Dear M/s Tozer,

I am aware that you have had very few working days to explore this application, and that only another five will pass before the close of consultation. Given the very challenging nature of the site and application, in the words of the WHSAP Examination, I have compiled the following to hopefully aid your work. The site has gone through Examination, Committee, and Public Inquiry, with each stage layering commitments onto the applicants (whether that be Waddeton Park, Savills or now Wain Homes). I hope that a summary herein will help to “short-circuit” the past nine years of stress-testing and conditioning which have formed the framework of a compliant and sustainable application. When these conditions are taken into consideration, it is clear that this application as submitted is neither compliant nor acceptable.

In the current application, the bridge length has been reduced, leading to the termination of the bridge and the ONLY access point being within Flood zones 1,2, and 3. As illustrated here from Planning layout sheet 2.

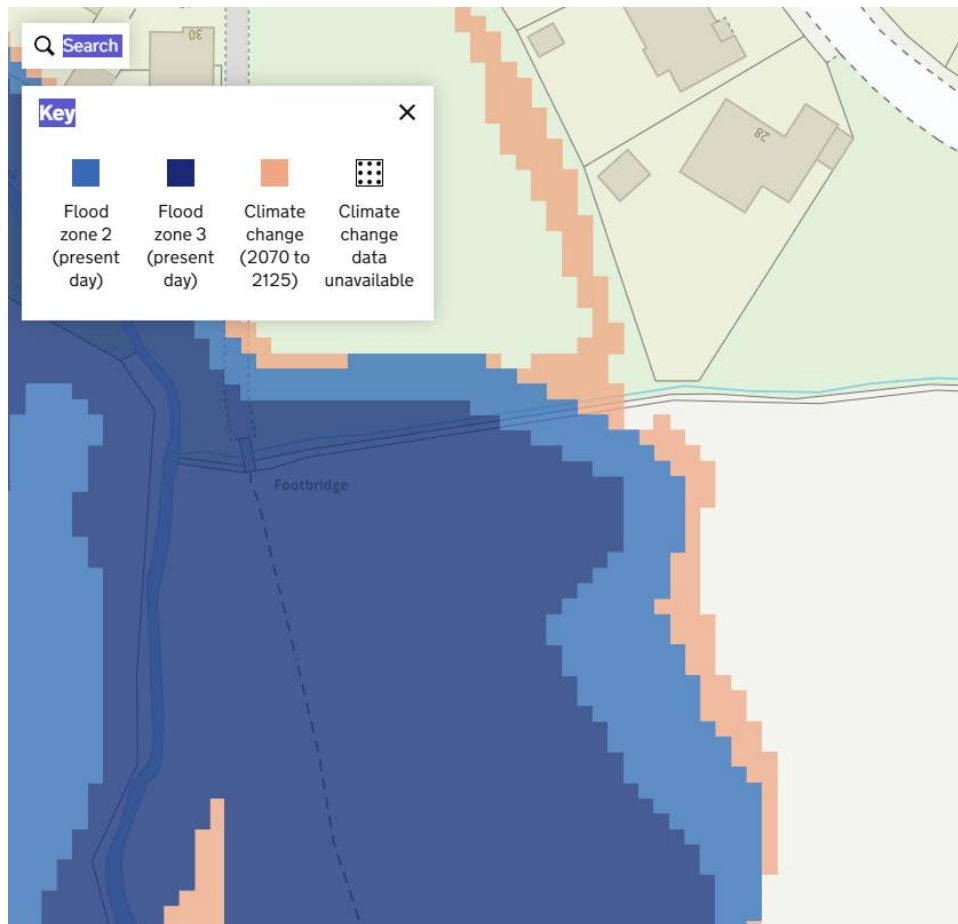
It should be noted that Flood Zone one has been omitted from this illustration, and also that curtilage and access for a number of units also falls within this designation, itself a further breach. Furthermore, the data on which this application is submitted is out-of-date and underestimates the situation. By focussing in on the area using the latest iteration of the Environment Agency Flood Map for Planning, and using the Lambrook and footpath as reference points, the extent of the Flood Zones have been significantly understated. This extends the inviolable FZ3 well into the new build.

Again, this disregards the additional surface water being added to the fluvial flow by the current proposal, making this data point doubly unreliable.

This renders the application in breach of National requirements regarding development on a flood plain, and unsustainable in its current form. The sole answer is to require the bridge and culvert to span the entirety of the flood zones, and in a greater length than the 100m first proposed and agreed to allow for the climate change modelling. To be clear, the entire proposed layout is untenable and must be sent back for compliant revision.

Figure 1. Core bat habitat feature, and associated buffer zones indicated for both development boundary features (above) and within development features

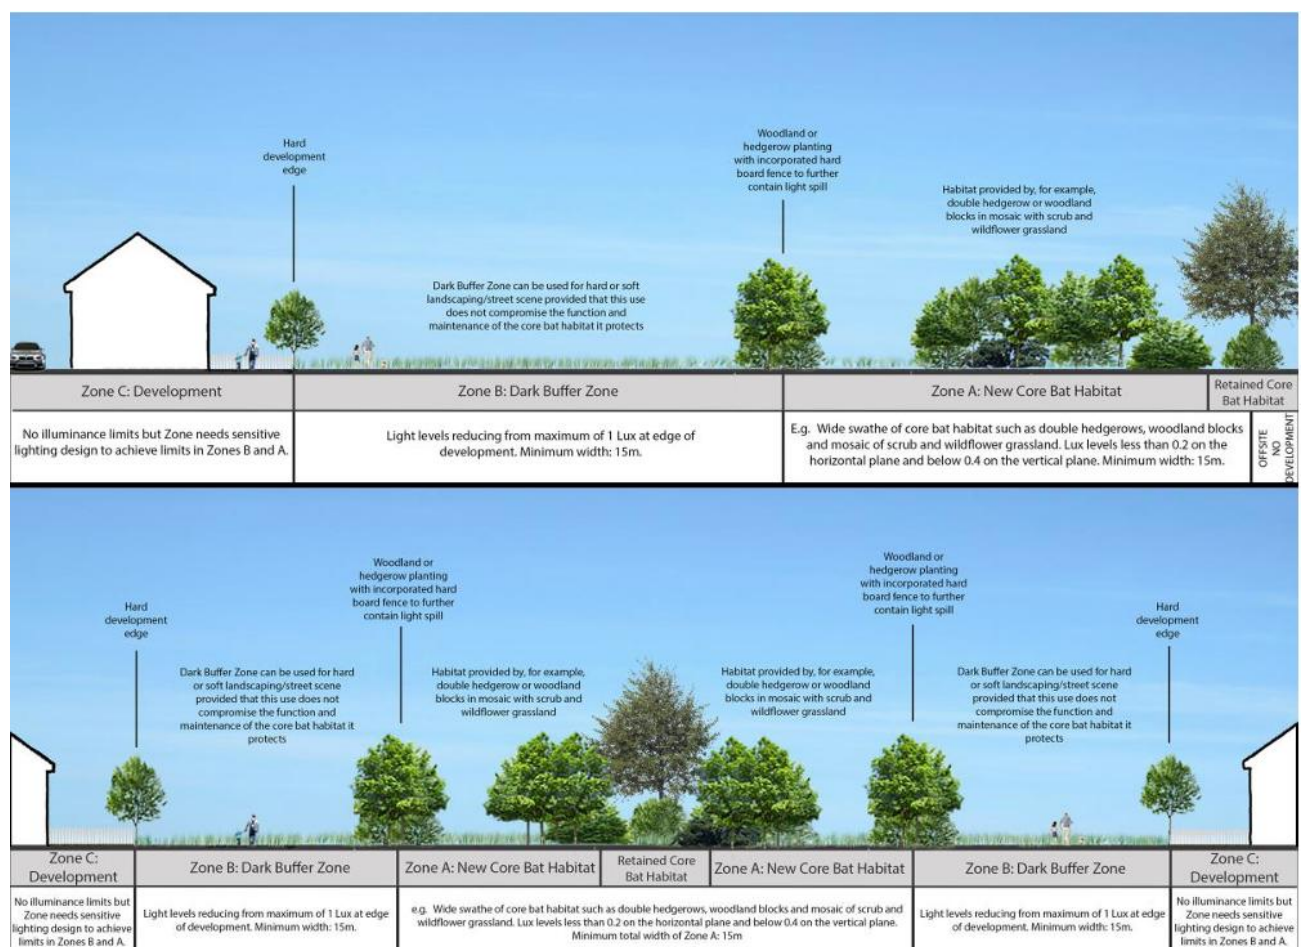
A cursory glance at the above, alongside comparison with the application shows:

- No planted boundary at the perimeter of Zone A.
- No hard-boarded fence at the perimeter of Zone A associated with the planting.
- No “mosaic of scrub and wildflower grassland”.

The detail in the application fails to deliver any of the above, suggesting wildflower alone will meet the requirements of the Policy/planning document. In parts of the application area not even this rudimentary condition is met. In the area running along the Lambrok, which must be in accordance with the lower illustration, this condition is breached twice with the multiple disregard of the hard-boarded fencing at the perimeter of both Zone A perimeters.
